AS-BUILT BASELINE MONITORING REPORT

KEY MILL MITIGATION SITE

RE: Task 6 – Final As-built Baseline Monitoring Report
Key Mill Mitigation Site, Surry County
Yadkin River Basin – HUC 03040101
DMS Project ID No. 100025 / DEQ Contract #7180

DMS comment: There was considerable storm damage caused to the site during the winter/spring 2020. Please include a brief discussion regarding the impact and changes to the timeline this had on construction, repairs and asbuilt/MY0 data collection that followed.

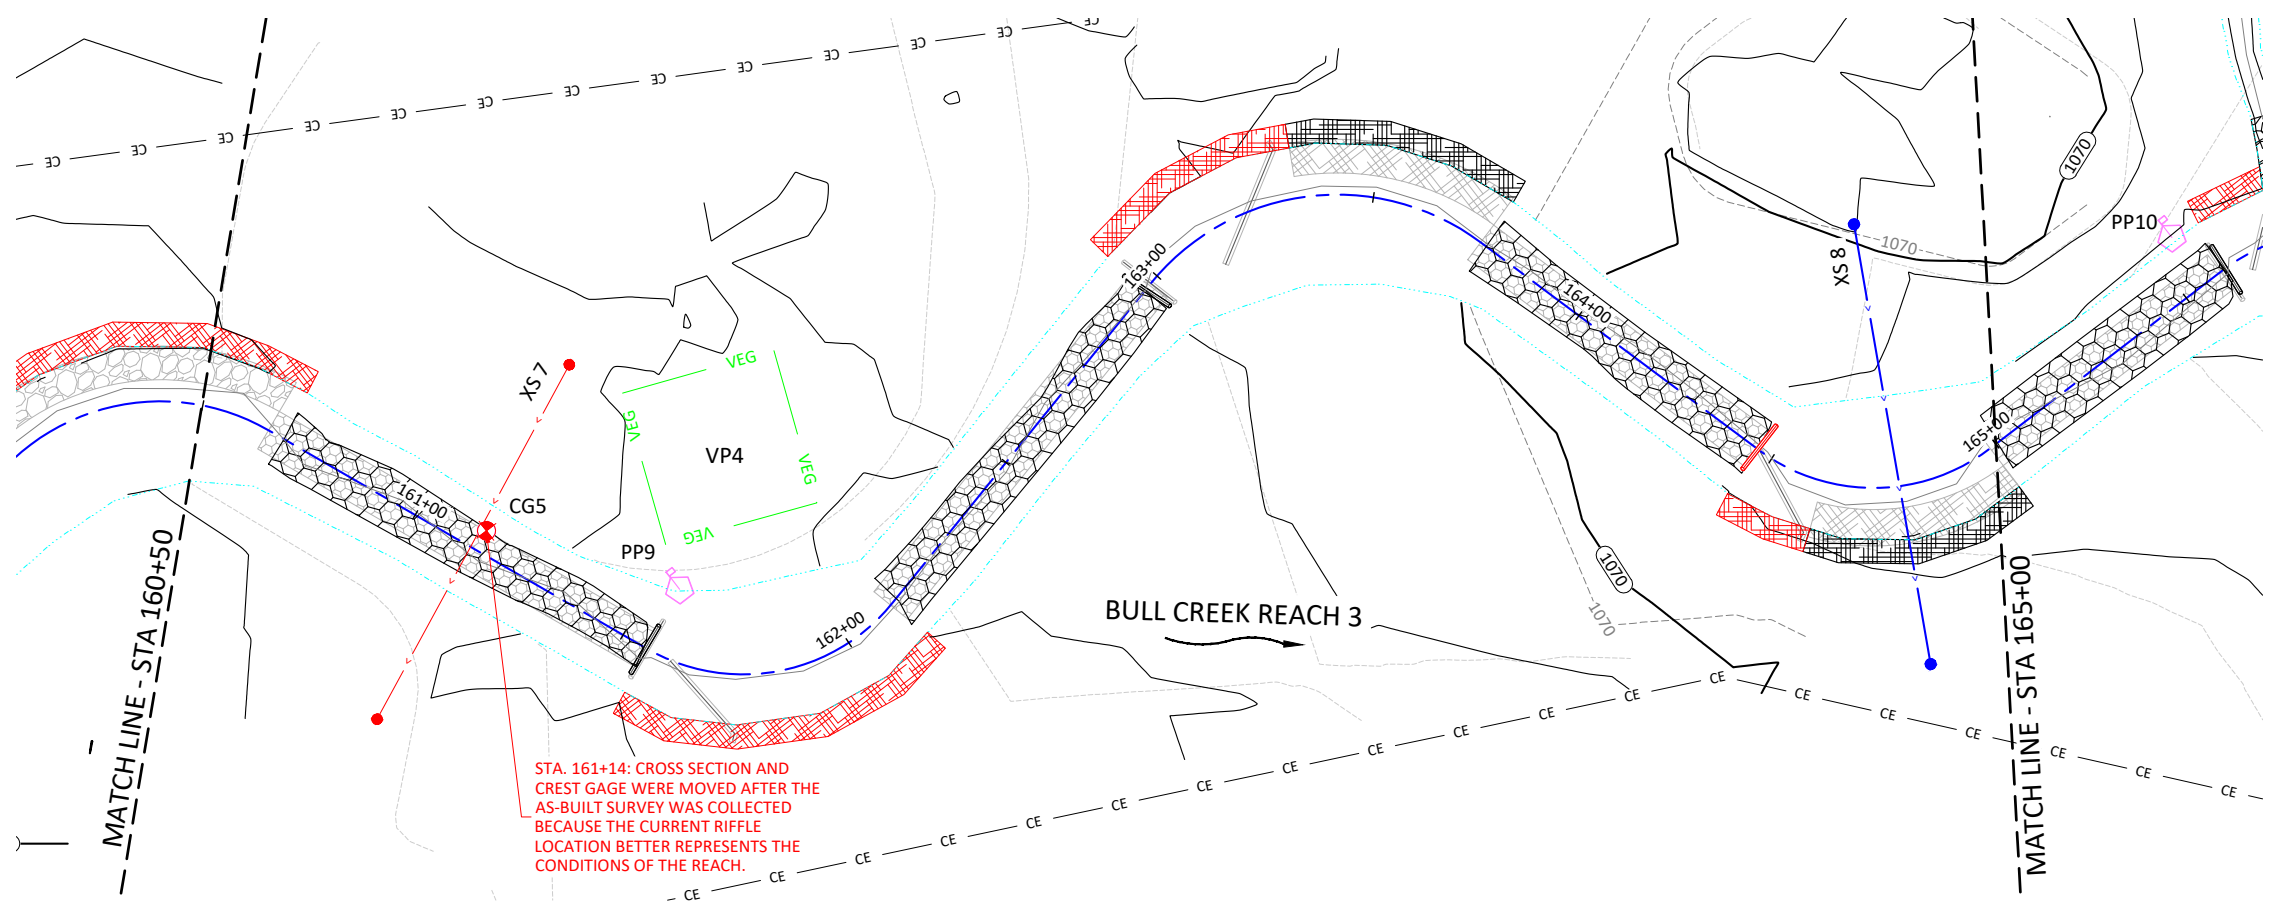
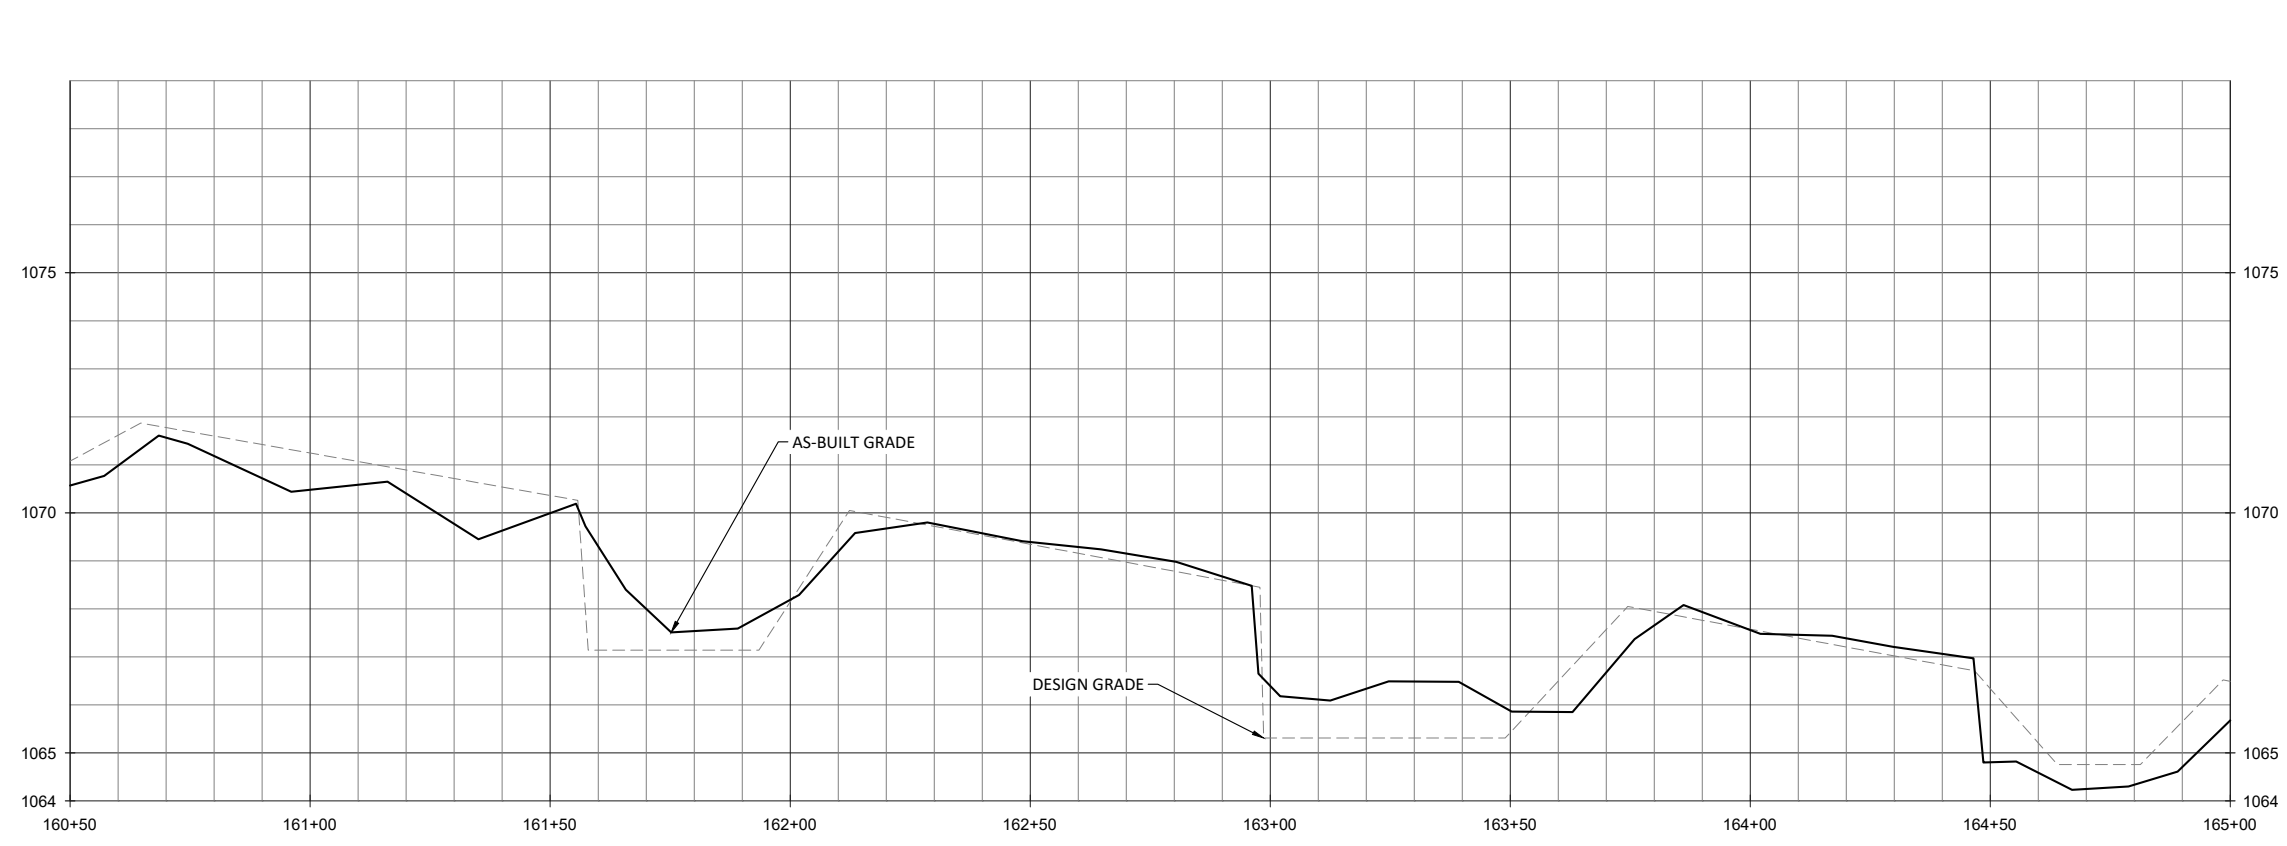
- NOTE:**
1. STA. 161+56: LOG VANE REMOVED AND BRUSH TOE ADDED TO OUTSIDE BANK TO IMPROVE STABILITY FOR THE ENTIRE OUTSIDE BANK.
 2. STA. 163+30: LOG VANE REMOVED AND BRUSH TOE EXTENDED DUE TO AVAILABILITY OF MATERIALS AND TO IMPROVE STREAM BANK STABILITY AND HABITAT.
 3. STA. 164+47: LOG VANE REMOVED, LOG SILL ADDED AND BRUSH TOE EXTENDED DUE TO LOCAL AVAILABILITY OF MATERIALS AND TO IMPROVE CHANNEL STABILITY AND HABITAT.

Key Mill Mitigation Site - Record Drawings
 Surry County, North Carolina
 UT1A
 Stream Plan and Profile

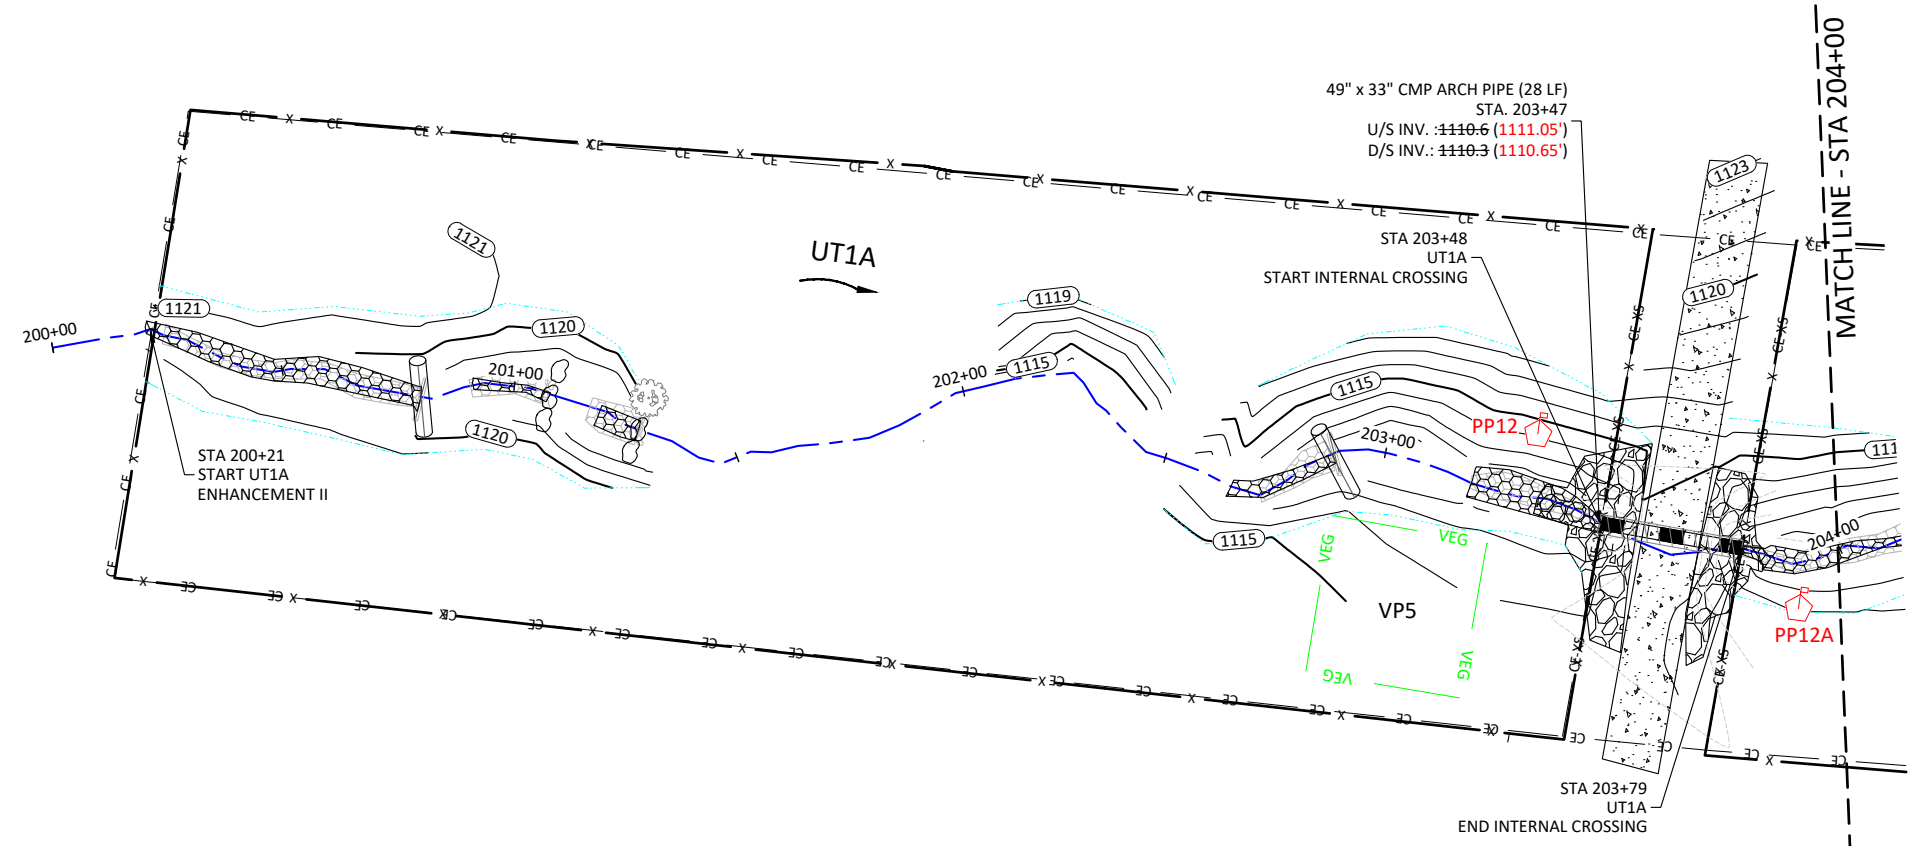
- NOTES:**
1. STA. 202+26: POOL WAS NOT EXCAVATED DUE TO EXISTING PROFILE STABILITY.
 2. STA. 203+32: PHOTO POINT 12 WAS MOVED AFTER THE SURVEY WAS COMPLETED AT THE REQUEST OF DMS TO CAPTURE A DOWNSTREAM VIEW OF THE CULVERT CROSSING.
 3. STA. 203+90: PHOTO POINT 12A WAS ADDED AFTER THE SURVEY WAS COMPLETED AT THE REQUEST OF DMS TO CAPTURE AN UPSTREAM VIEW OF THE CULVERT CROSSING.

Key Mill Mitigation Site - Record Drawings
Surry County, North Carolina
 UT1B
 Stream Plan and Profile

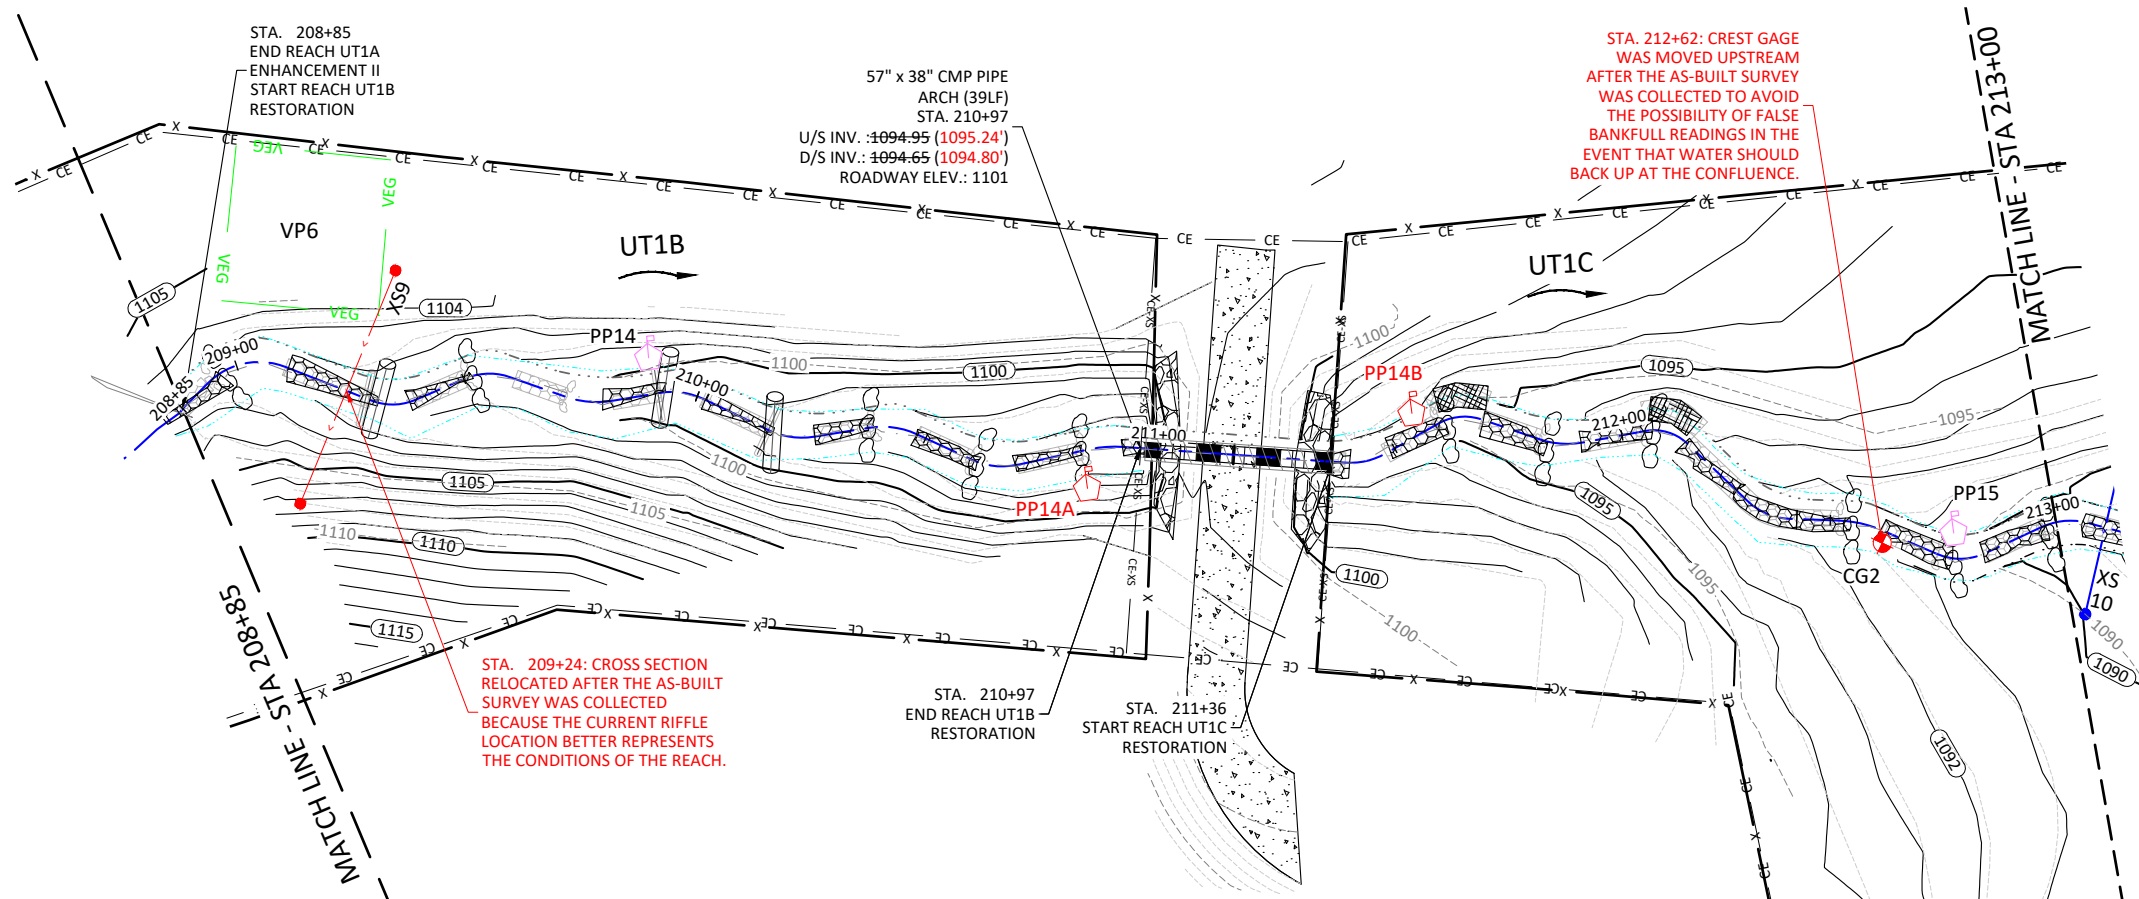
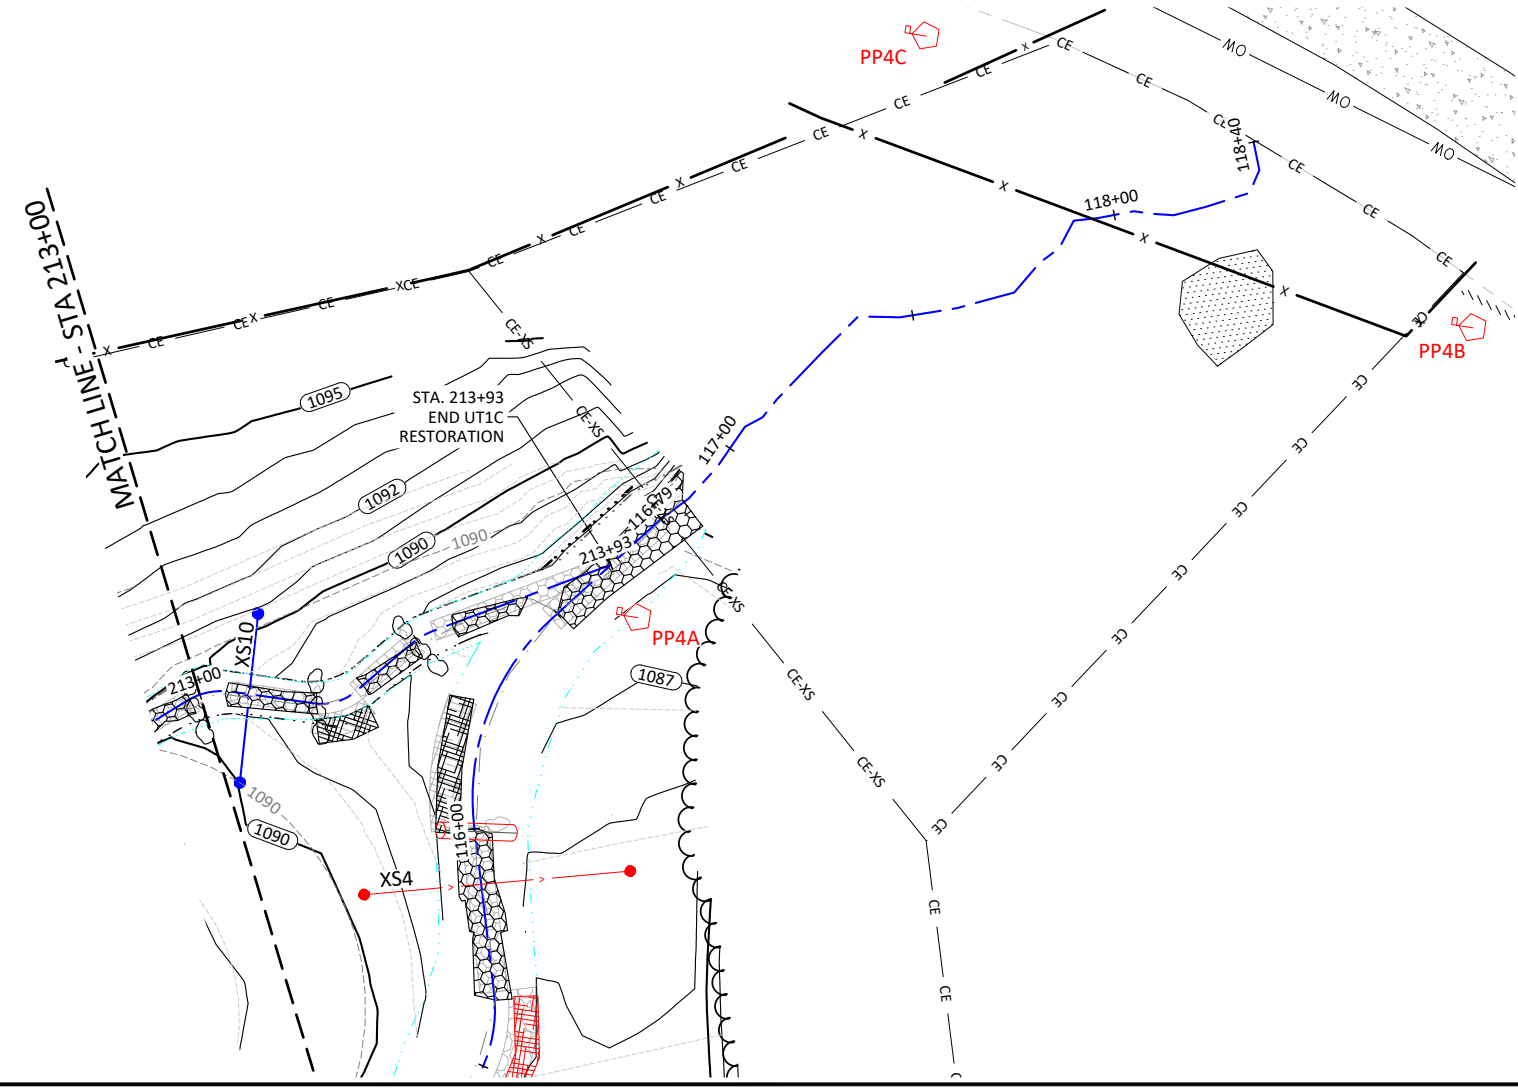
- NOTE:**
1. STA. 209+65: RIFFLE, ROCK SILL AND POOL WERE OMITTED DUE TO SUFFICIENT STABILITY AND SLOPE ON THE REACH.
 2. STA. 210+83: PHOTO POINT 14A WAS ADDED AFTER THE SURVEY WAS COMPLETED AT THE REQUEST OF DMS TO CAPTURE A DOWNSTREAM VIEW OF THE CULVERT CROSSING.
 3. STA. 211+57: PHOTO POINT 14B WAS ADDED AFTER THE SURVEY WAS COMPLETED AT THE REQUEST OF DMS TO CAPTURE AN UPSTREAM VIEW OF THE CULVERT CROSSING.
 4. STA. 212+35: UPSTREAM ROCK AND ROLL RIFFLE BOULDER SILL WAS OMITTED AND RIFFLE WAS EXTENDED TO CONNECT TO DOWNSTREAM ROCK AND ROLL RIFFLE.

Key Mill Mitigation Site - Record Drawings
Surry County, North Carolina
 UT3 and UT3A
 Stream Plan and Profile

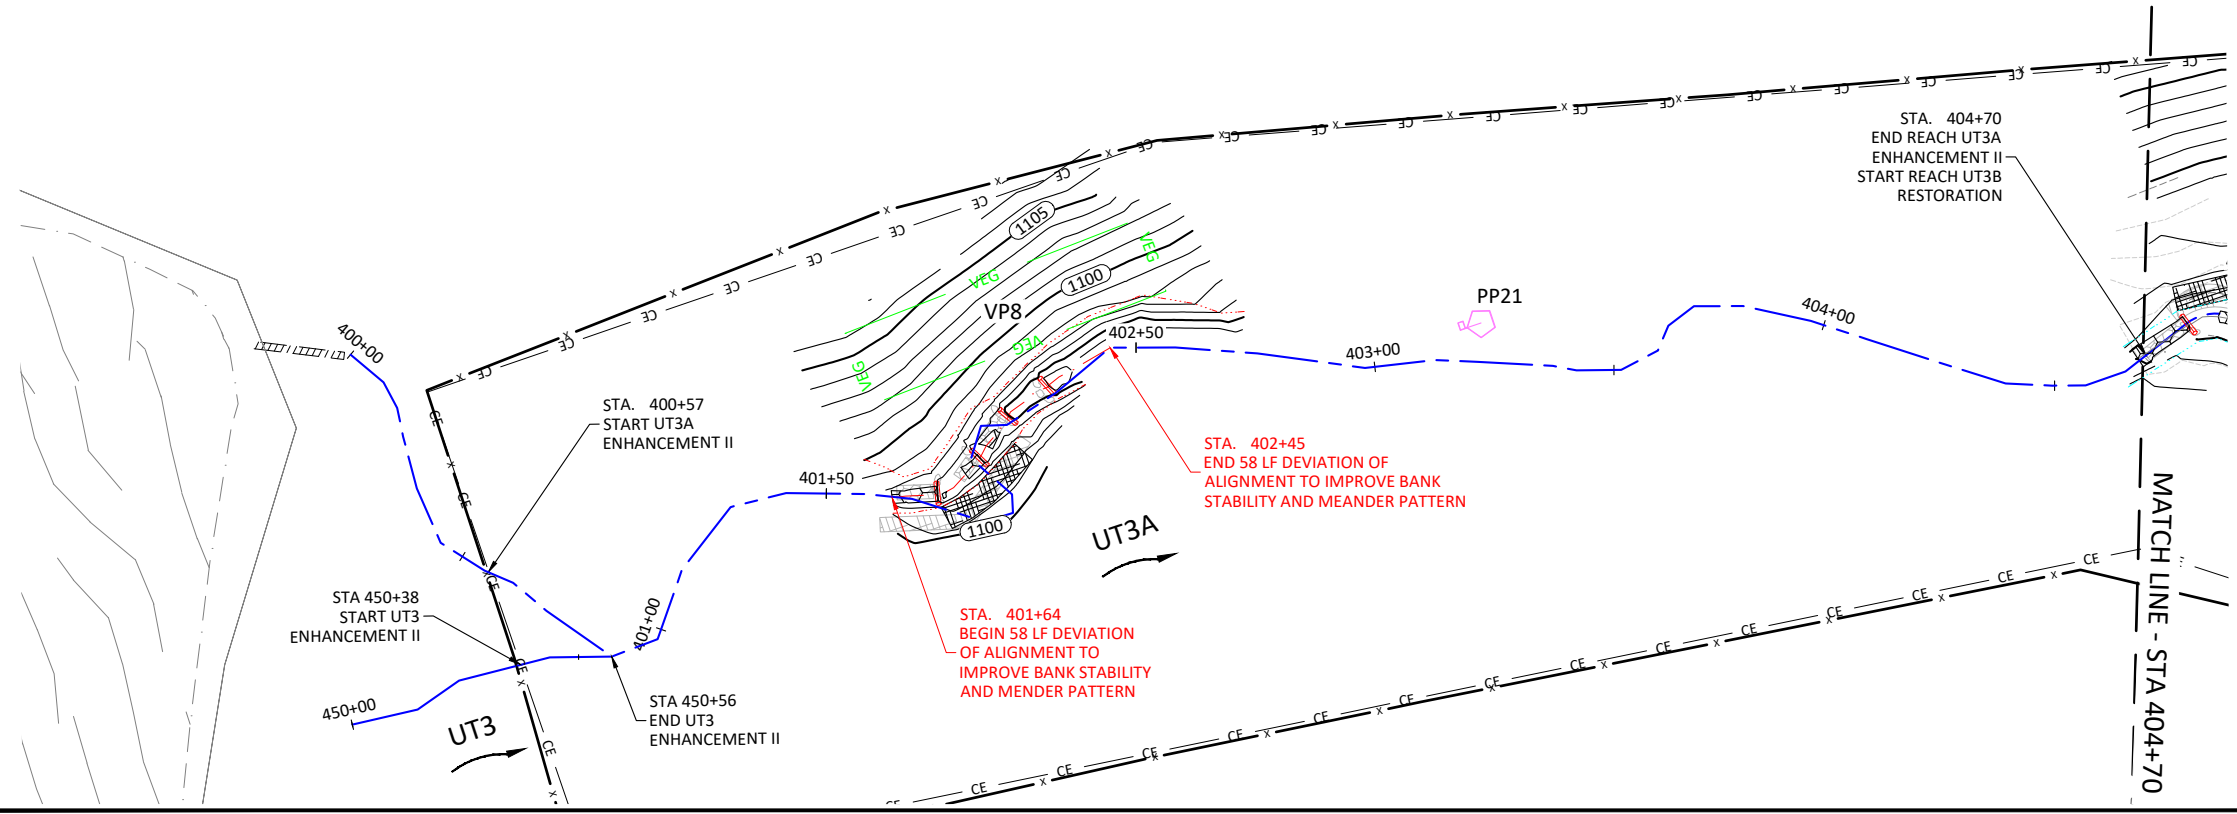
- NOTE:**
1. STA. 401+64 - 402+45: THE CHANNEL DESIGN WAS ALTERED AND REALIGNED TO IMPROVE BANK STABILITY AND MEANDER PATTERN WHICH RESULTED IN 58 LF OF CONSTRUCTED CHANNEL, COMPARED TO 81 LF IN THE ORIGINAL DESIGN.
 2. STA. 401+71 - 402+29: ROCK SILLS REPLACED WITH LOG SILLS DUE TO LOCAL MATERIAL AVAILABILITY AND SIMILAR FUNCTIONALITY.
